UNITED STATES PATENT AND TRADEMARK OFFICE

APPLICATION NO.	FILING DATE	FIRST NAMED INVENTOR	ATTORNEY DOCKET NO.	CONFIRMATION NO.
09/977,528	10/12/2001	James Hong	ACS 57818	4201

Office Action Summary

DETAILED ACTION

Fig. 1

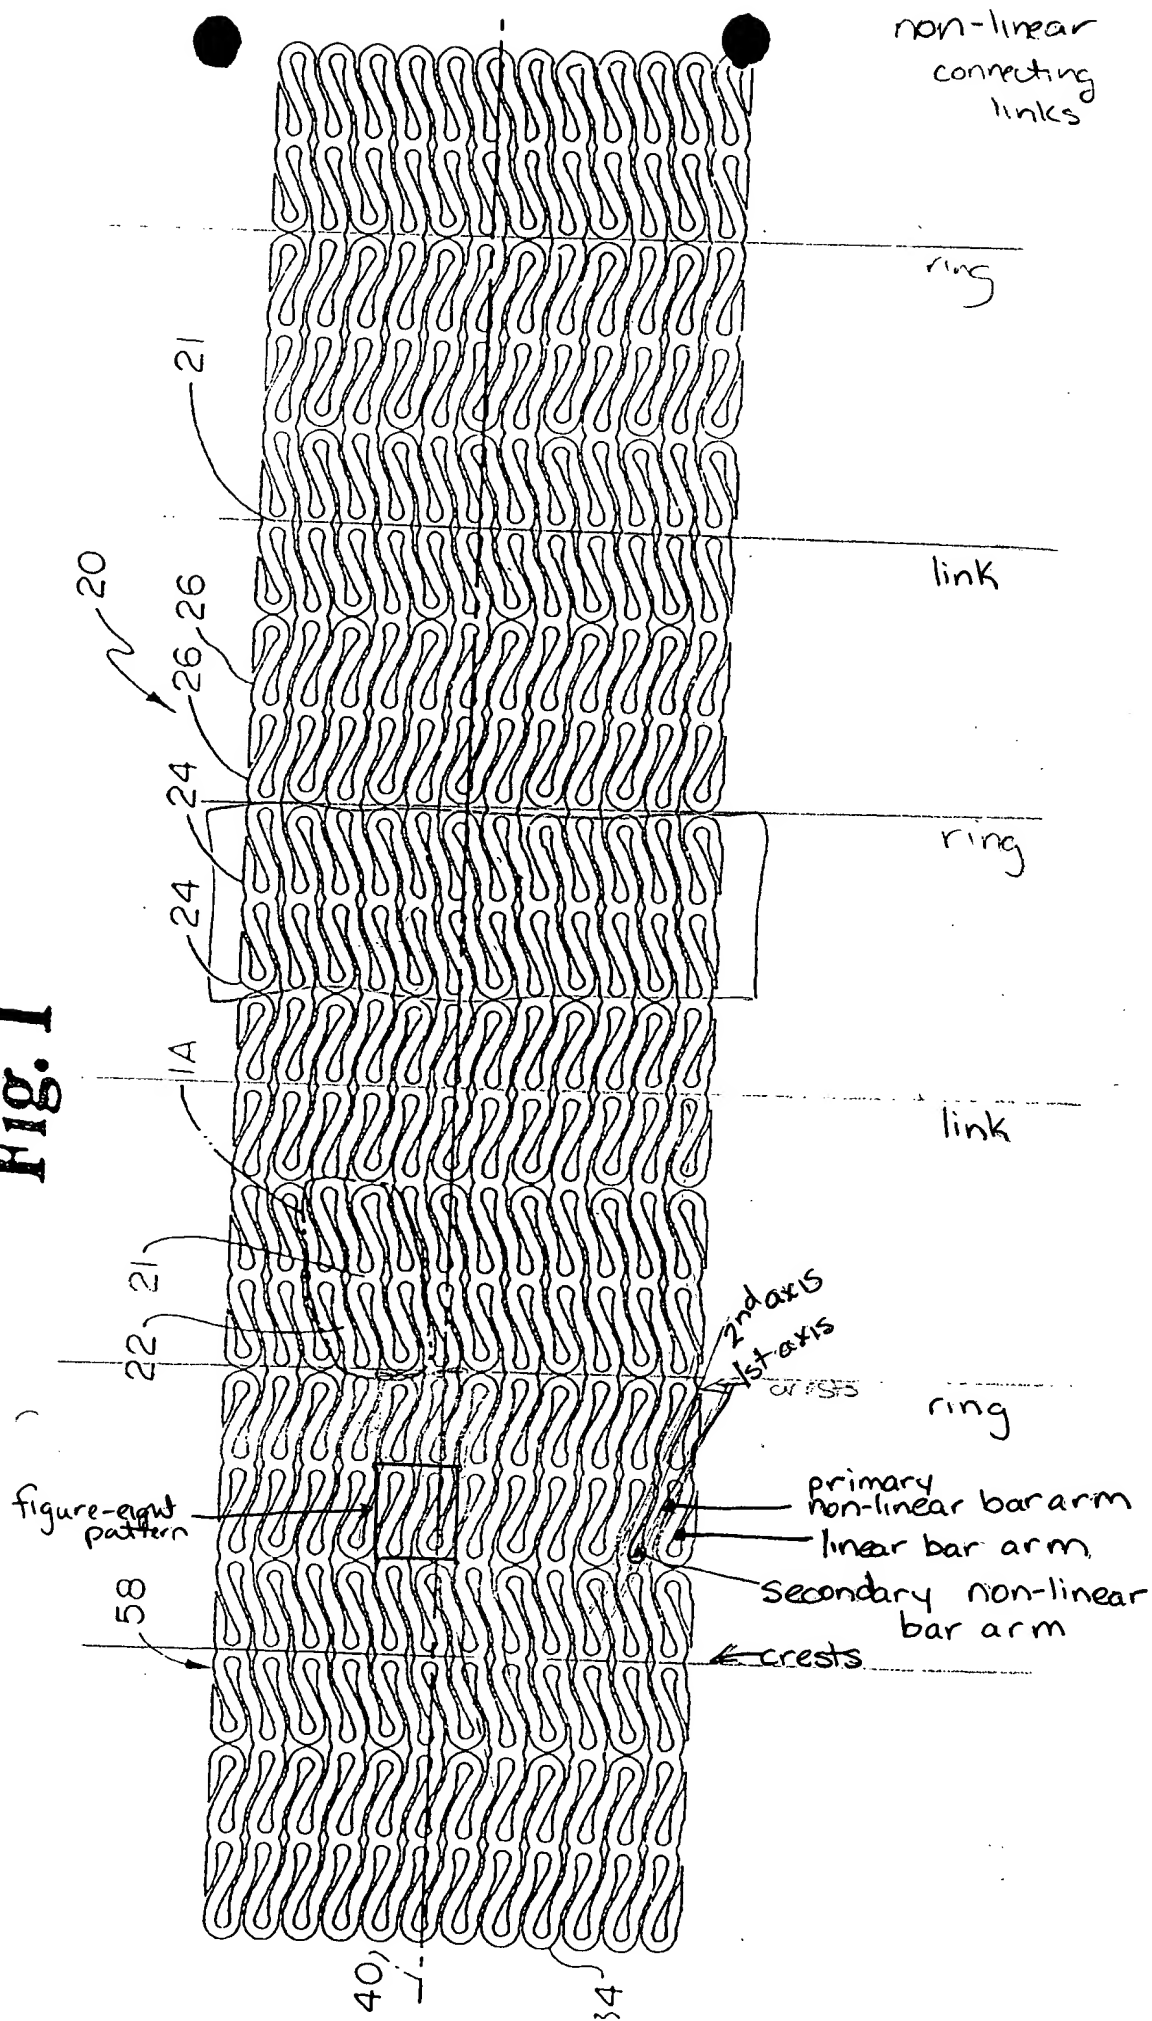
Regarding claims 1-21, 30 and 31, please see the attached figure 1 for the structural limitations of the claimed stent.
